# ENVIRONMENTAL ASSESSMENT REPORT

## Silverton Wind Farm Project Approval Modification 3 (08\_0022 MOD 3) and Concept Approval Modification 2 (08\_0022 MOD 2)

Figure 3: Proposed Modification

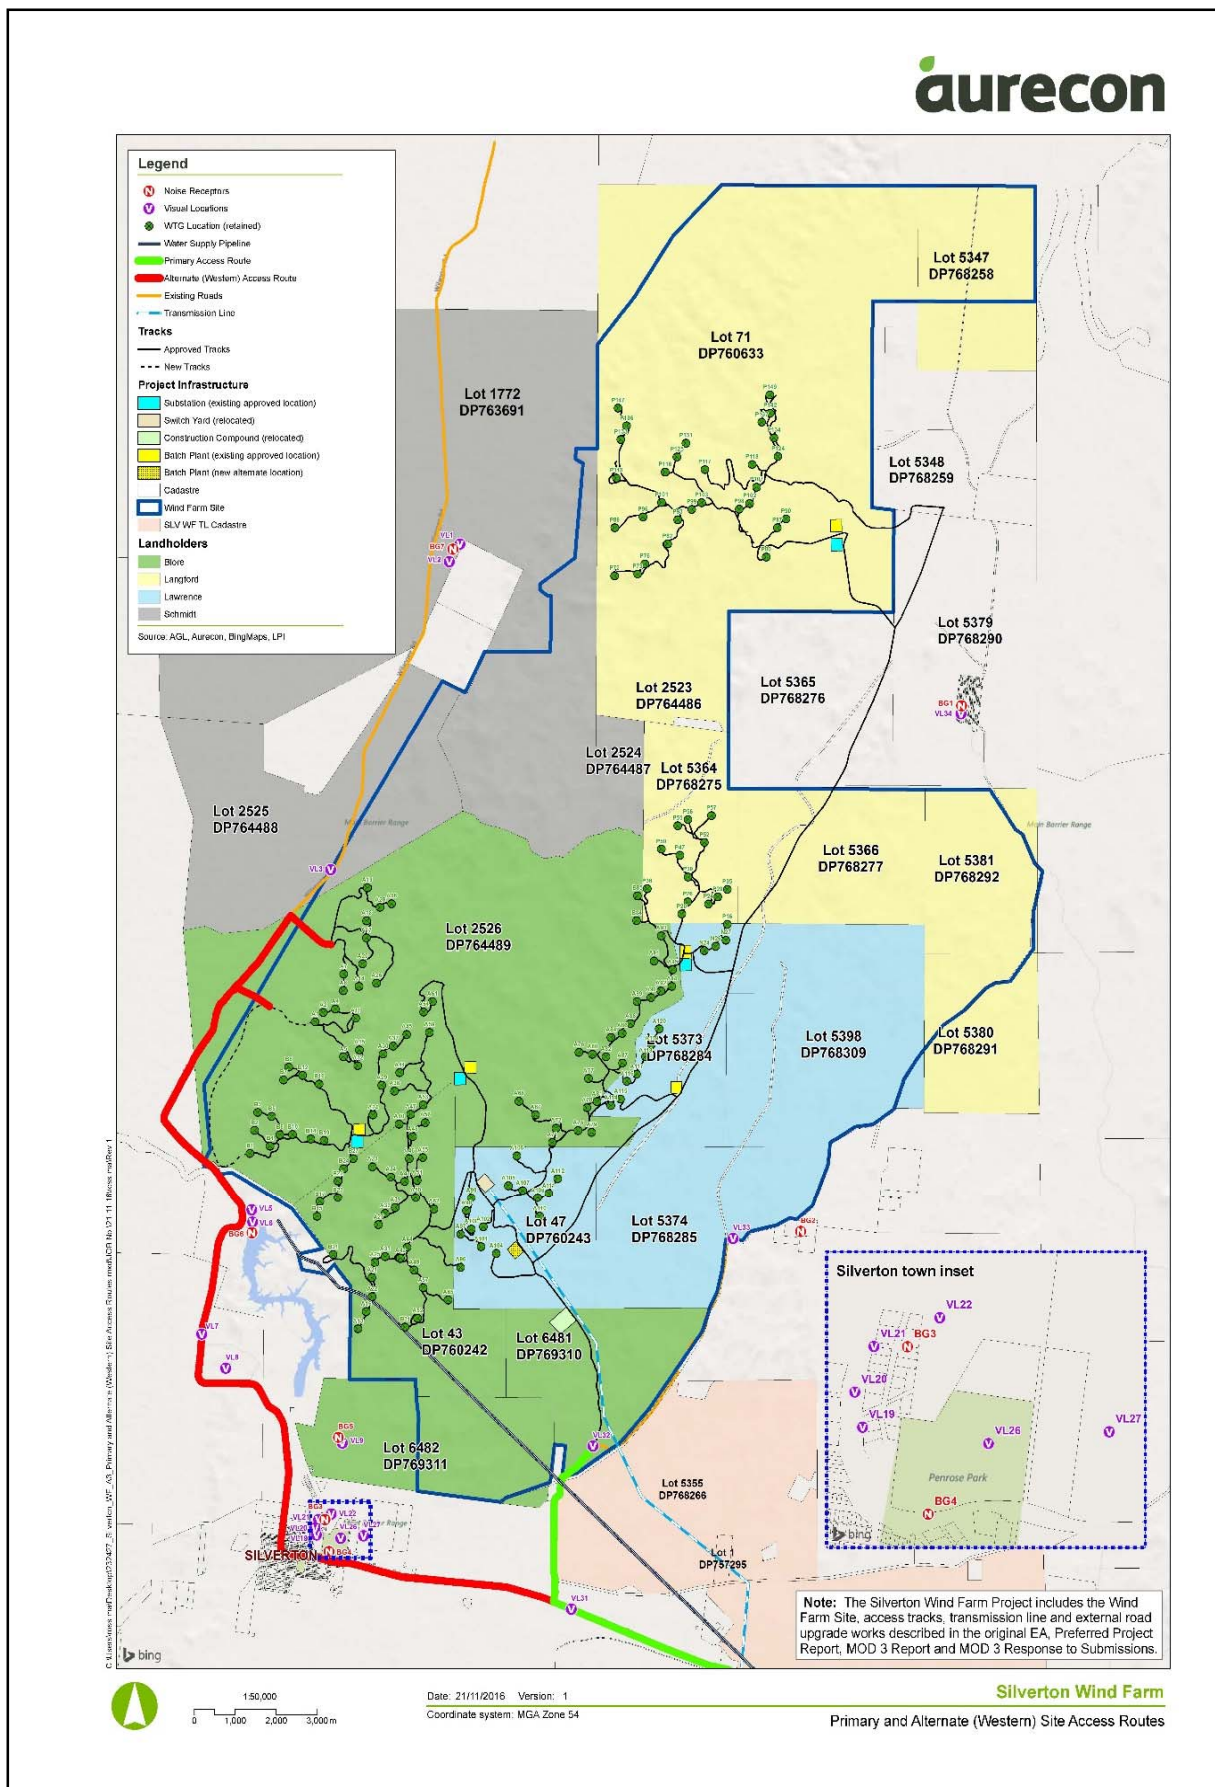
Since the application was lodged, AGL has removed another 2 turbines (B009 and B013) from the proposed layout to reduce visual impacts on the caretaker's residence at the Umberumberka Reservoir (i.e. VL6) and the public viewpoint at VL8 (see Figure 3).

**Figure 6: Northern Cluster – Deleted Turbines**

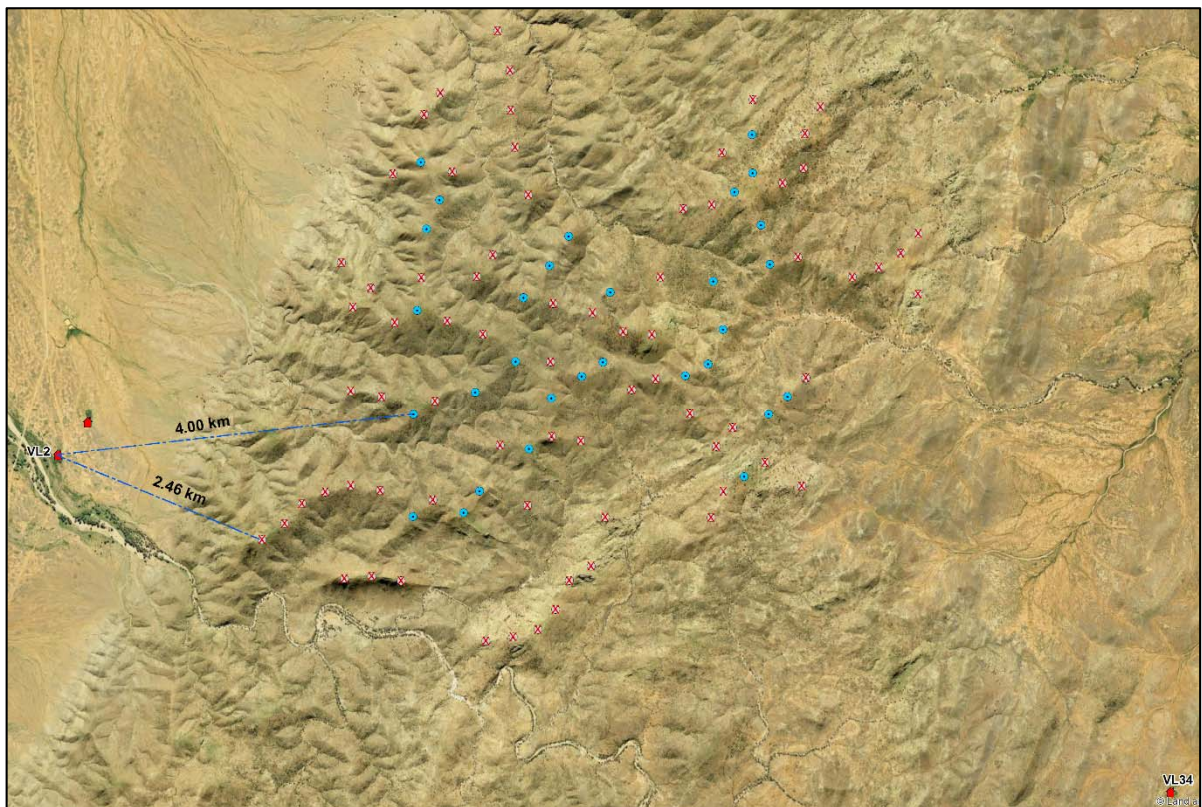
Figures 6 and 7 show the deletion of turbines in more detail, and Table 2 sets out the revised setback distances from surrounding residents and public viewpoints.

**Figure 8: Deletion of Turbines near Umberumberka Reservoir**

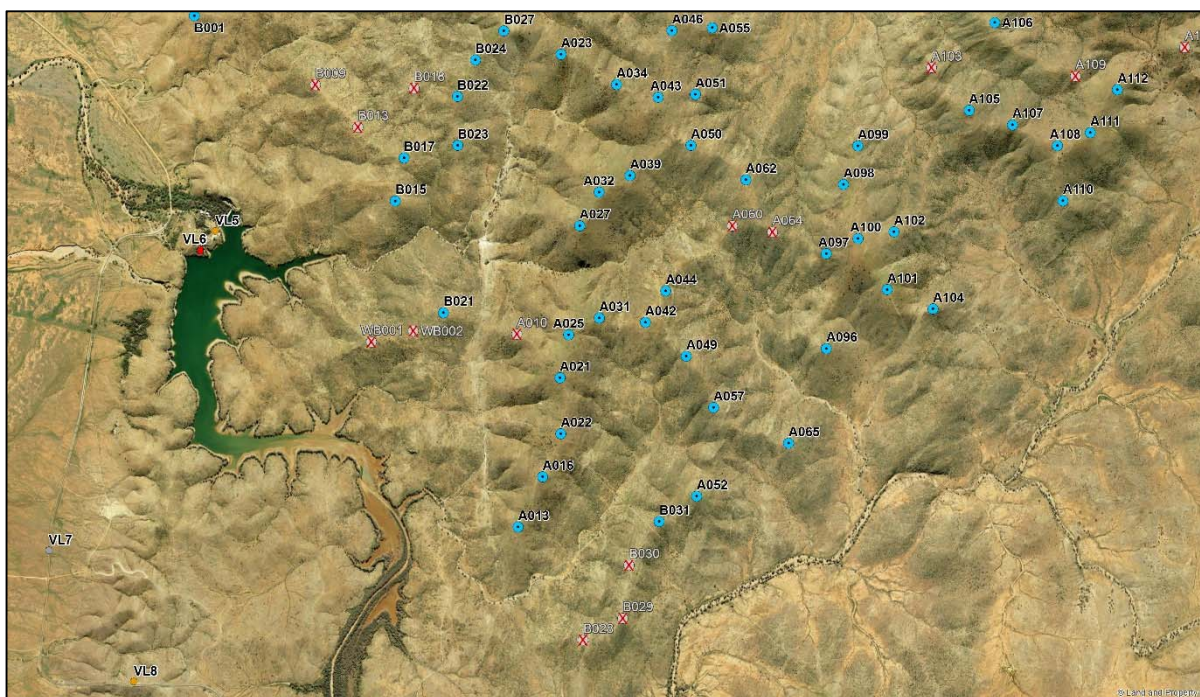
During the assessment process, the Department raised concerns about the visual impacts of the larger turbines on the caretaker’s residence (VL6), and the nearby Mundi Mundi Lookout (VL8).

In response to these concerns AGL is now proposing to delete two more of the closest turbines to the caretaker’s residence (B009 and B013), in addition to the turbines it already proposes to delete in this precinct (see Figure 8).

While this would only marginally decrease the setback from the residence (from 1.58 to 1.63 km), it would reduce the total number of turbines visible from the residence, and the extent of the horizontal view where turbines would be visible.
